Our File: 9506

June 10, 2014

**Re: Letter - Response to Burnside Review of Summary of Drilling and Testing of New Well M15 at Hidden Quarry Site (Burnside Response April 8, 2014)  
Harden Response to Burnside Review of Hydrogeological Summary Report (Burnside Response April 9, 2014)  
Hidden Quarry Site for Township of Guelph/Eramosa  
Burnside File No.: 300032475.0000**

**Figure 11: M3 Hydrograph**

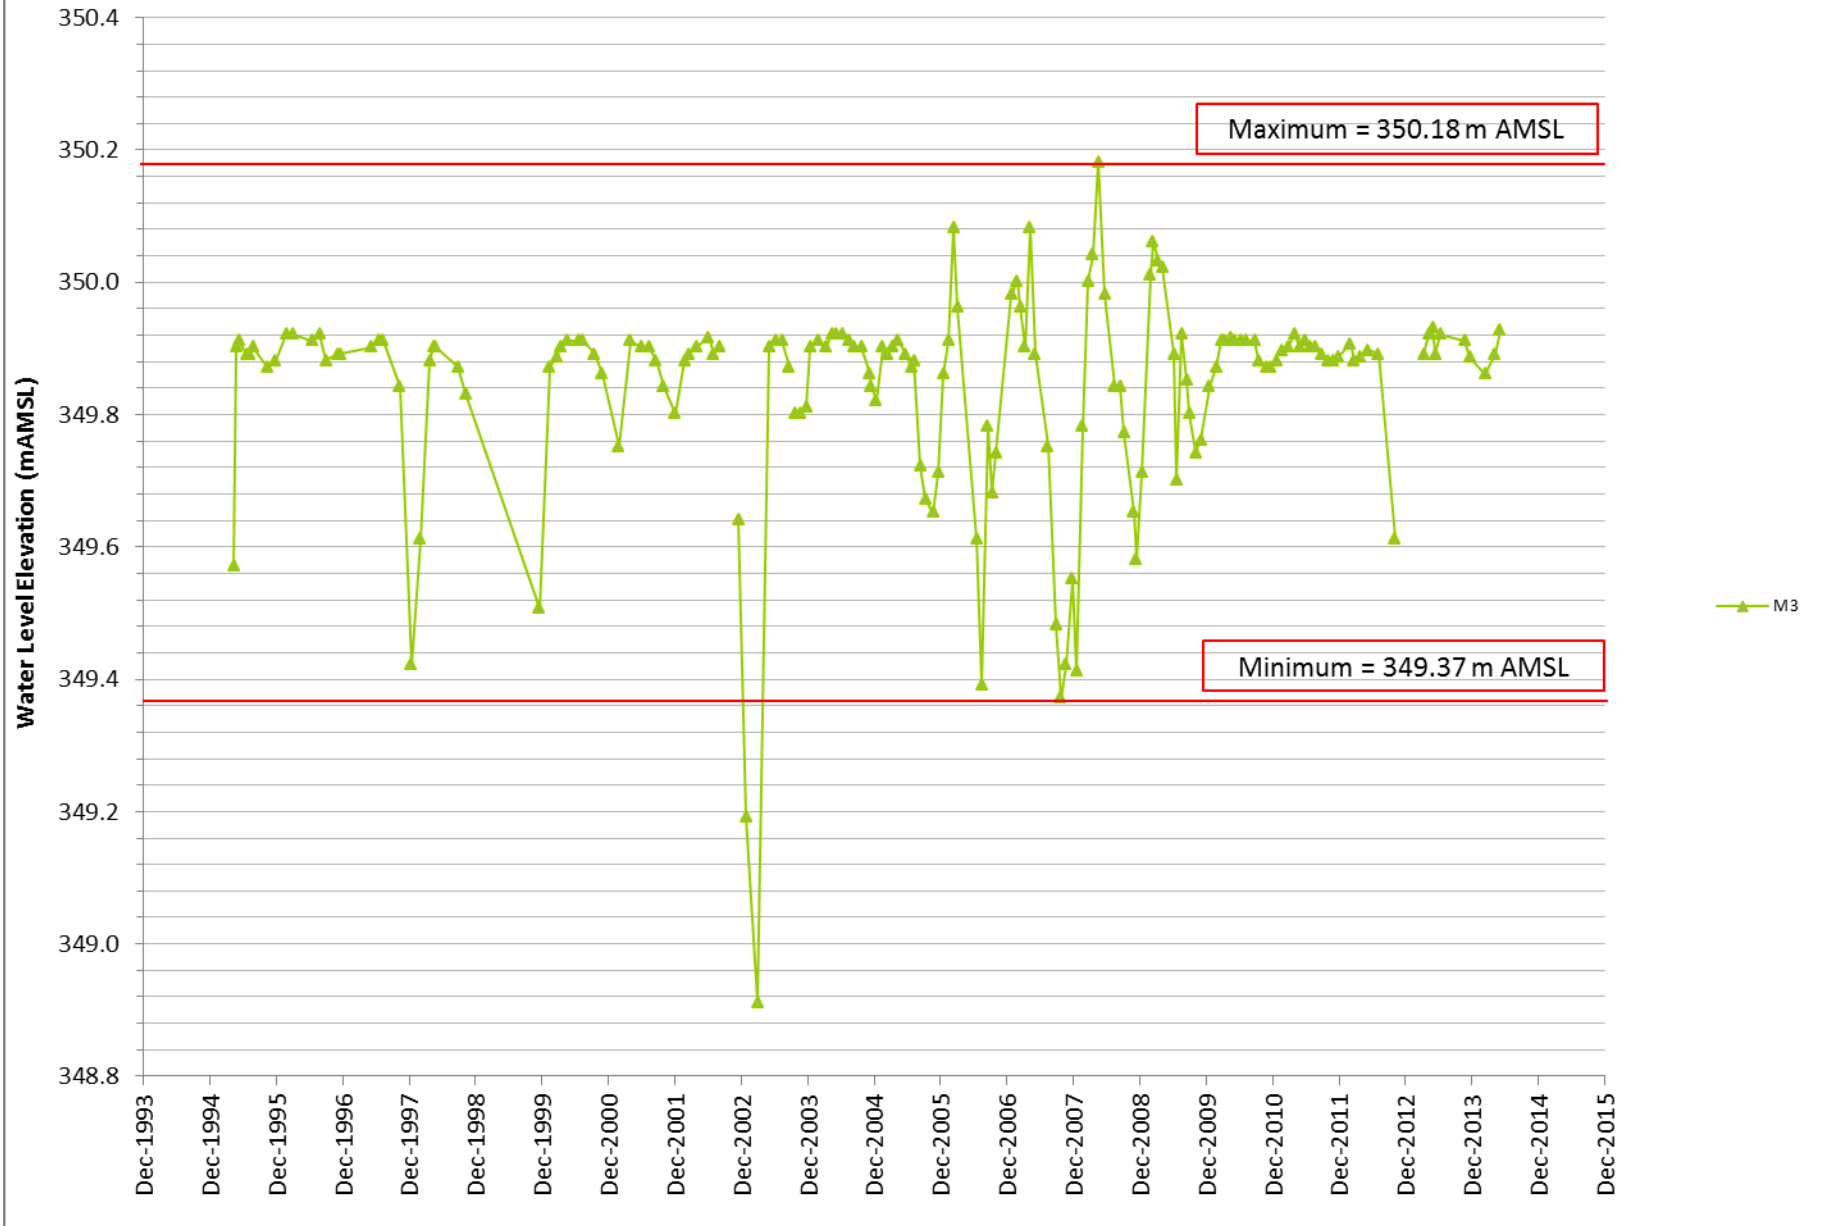
The nearest groundwater monitor to the sinking cut is M3. The hydrograph of M3 is found attached as Figure 11. The low water level in M3 is 349.37 m AMSL. We propose to use this as the reference elevation resulting in a minimum allowable water elevation in the sinking cut of  $349.37 - 2.54 = 346.83$  m AMSL. JDCL proposes to hang a buoy from a tether with the buoy floating in the water until the water level falls below an elevation of 346.83 m AMSL. The buoy will be a visual indicator of the minimum allowable water level to the operator. Once the extraction face has been established, a level logger will be used to verify that water levels in the sinking cut do not fall below 346.83 m AMSL.

There will only be two sinking cuts necessary for this quarry, one each on the east and west sides of Tributary B. James Dick Construction Ltd. is agreeing to a maximum water level change of 2.54 m in each sinking cut.
